Report of Change and Summary of 50.54(q) Analysis – Emergency Plan Implementing Procedure 5.7.6, Revision 69

Emergency Plan Implementing Procedure 5.7.6, Revision 69

EMERGENCY PLAN IMPLEMENTING PROCEDURE
5.7.6
NOTIFICATION

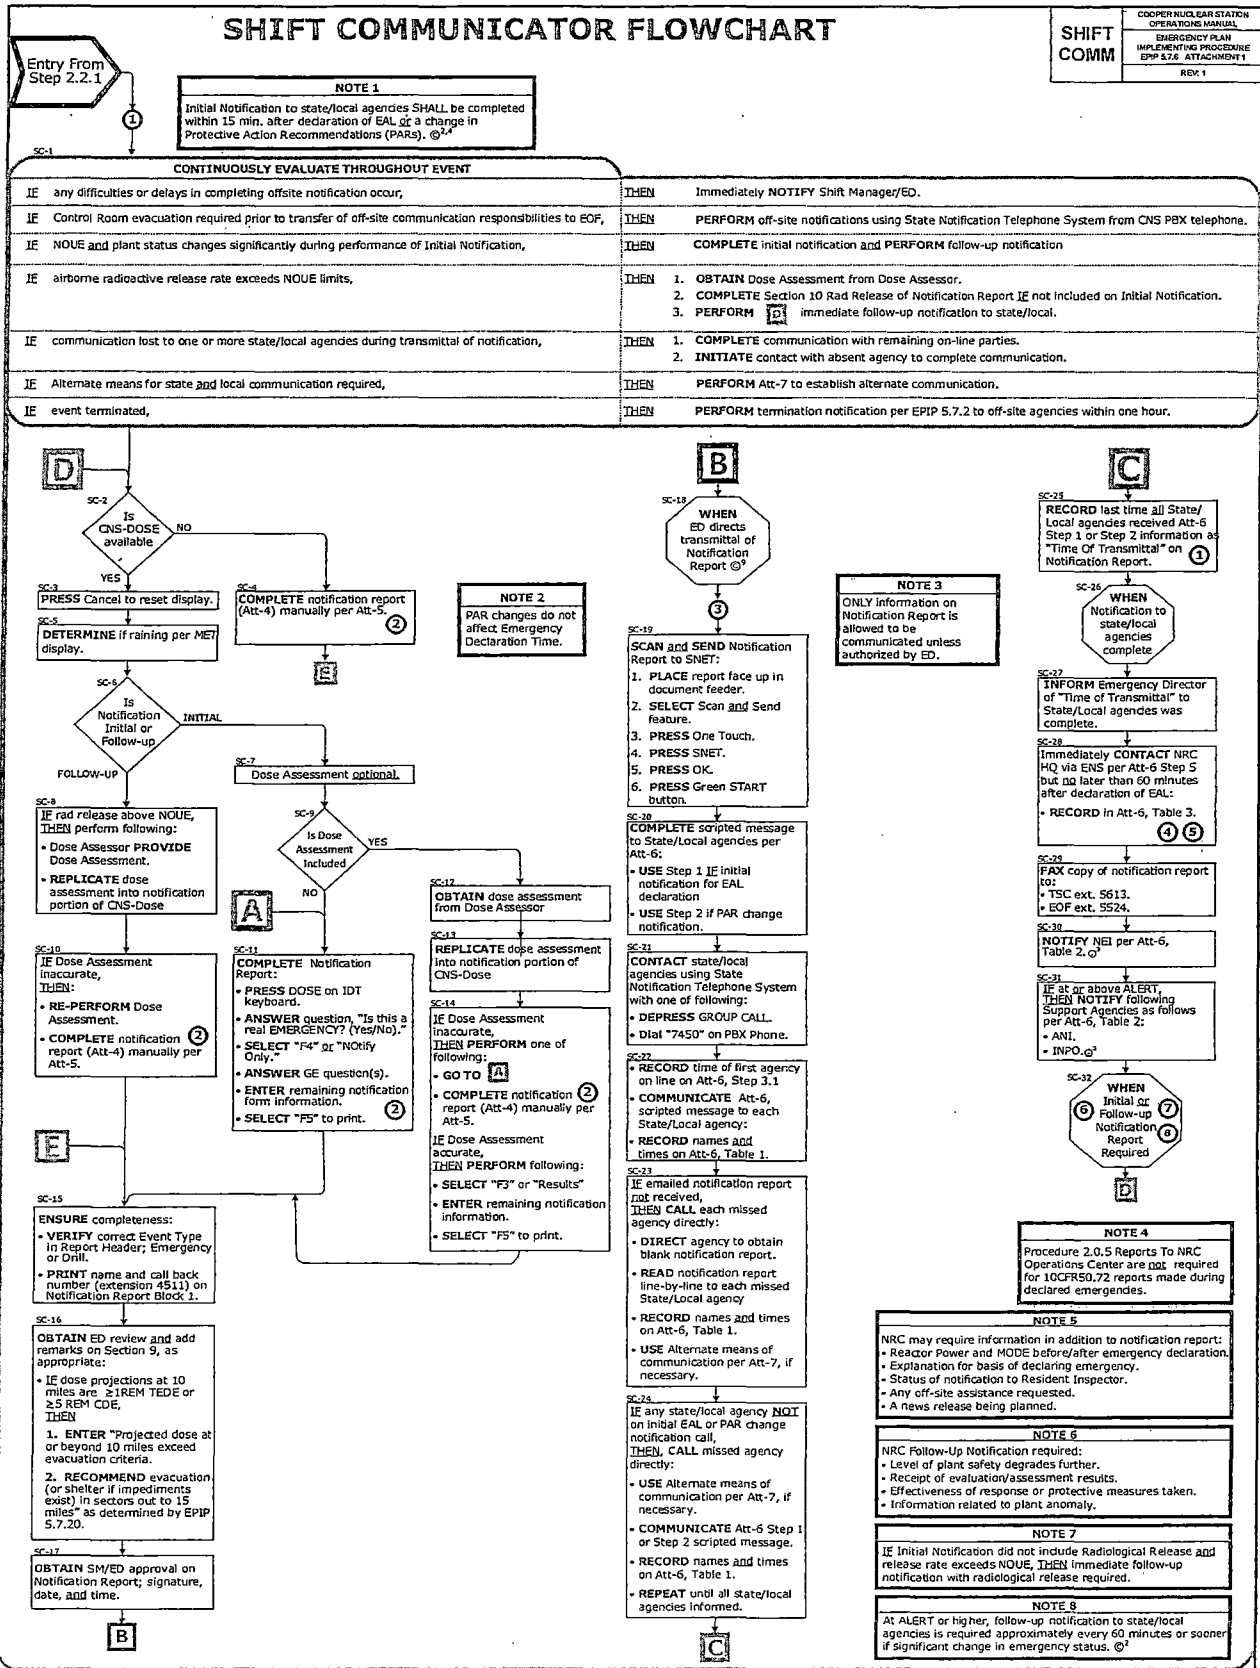
Emergency Plan Implementing Procedure (EPIP) 5.7.6, Attachment 1 and 3 flowcharts, were revised (boxes SC-14 and OFS-14) to add steps for completing the notification. Also the EPIP had previously allowed the user to inappropriately skip Step 3 of Attachment 5 for recording meteorological conditions and release status information when completing the notification report. This step was inadvertently omitted during a previous rewrite of the procedure and has been corrected and again is a requirement for completing the notification with CNS-DOSE unavailable.
